GEORGE HALL MPR AND SUPPORT ROOMS PROJECT #19-143

ADDENDUM NO. 2

Date: November 19, 2021

Project: #19-143 George Hall MPR and Support Rooms Project
DSA #: 01-119574 41-26

SHEET NAME:
WINDOW / WALL OPENING DETAILS

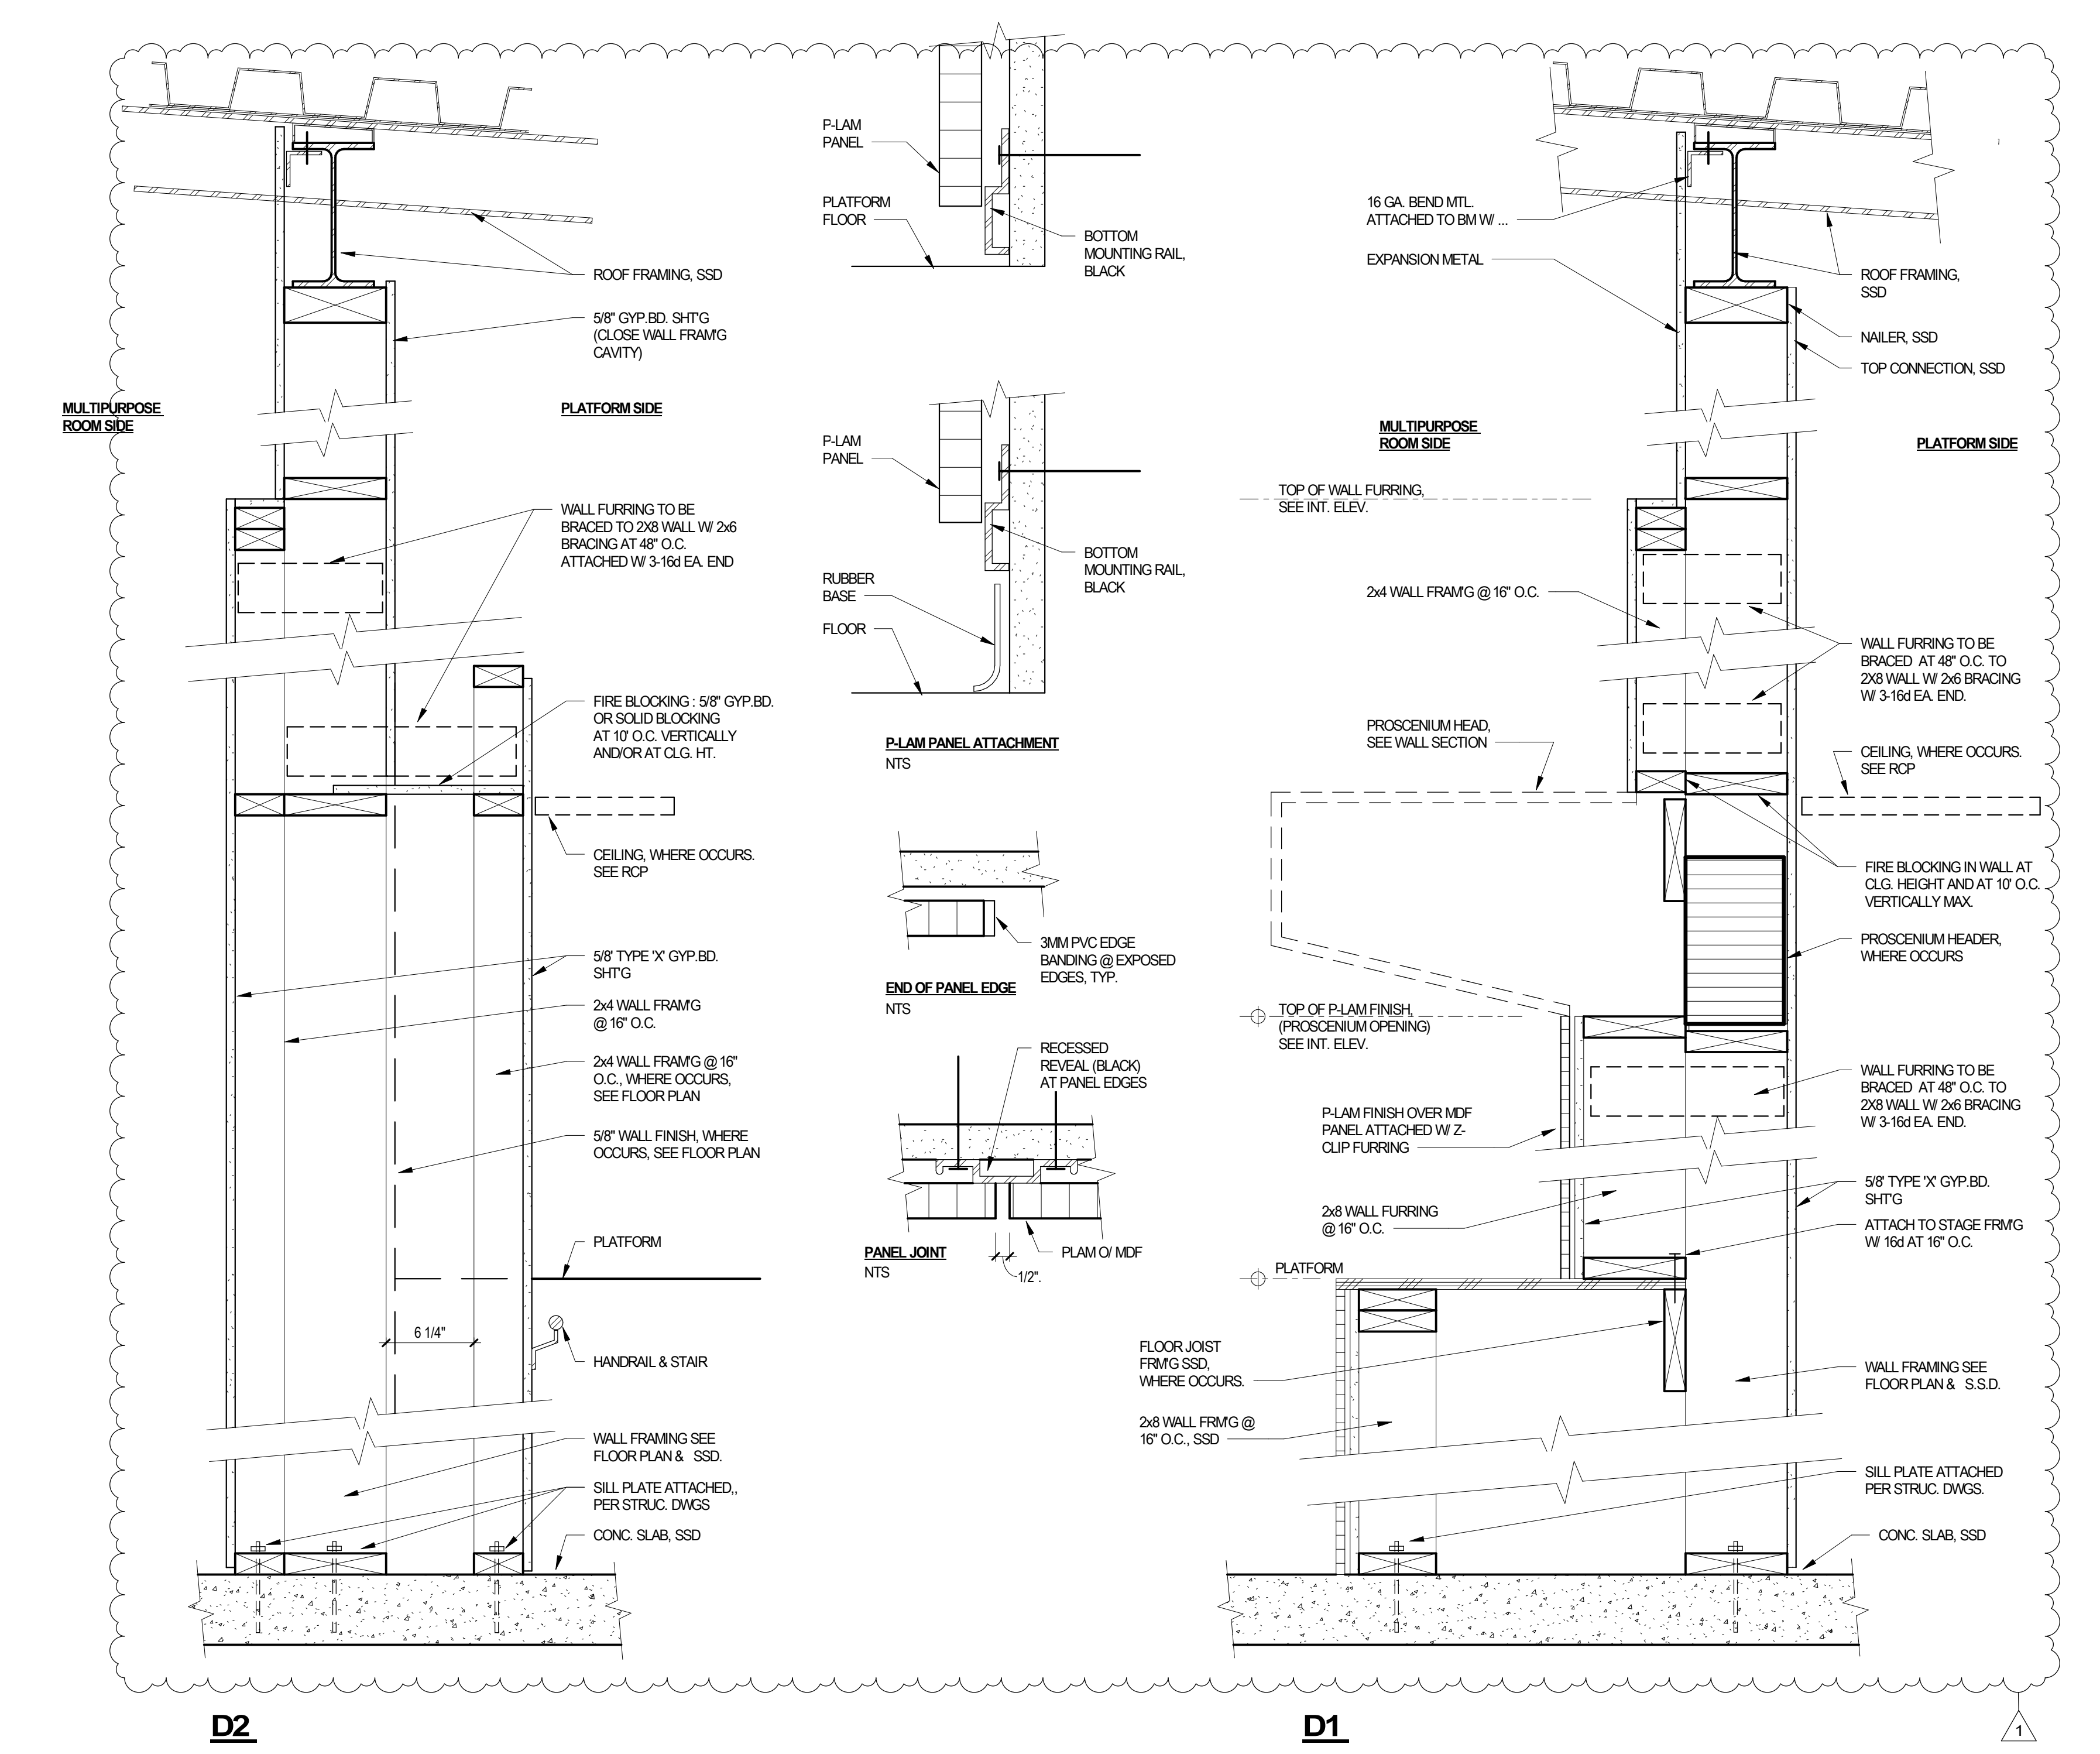
A. Revised detail with backing and insulation for window brake shape.
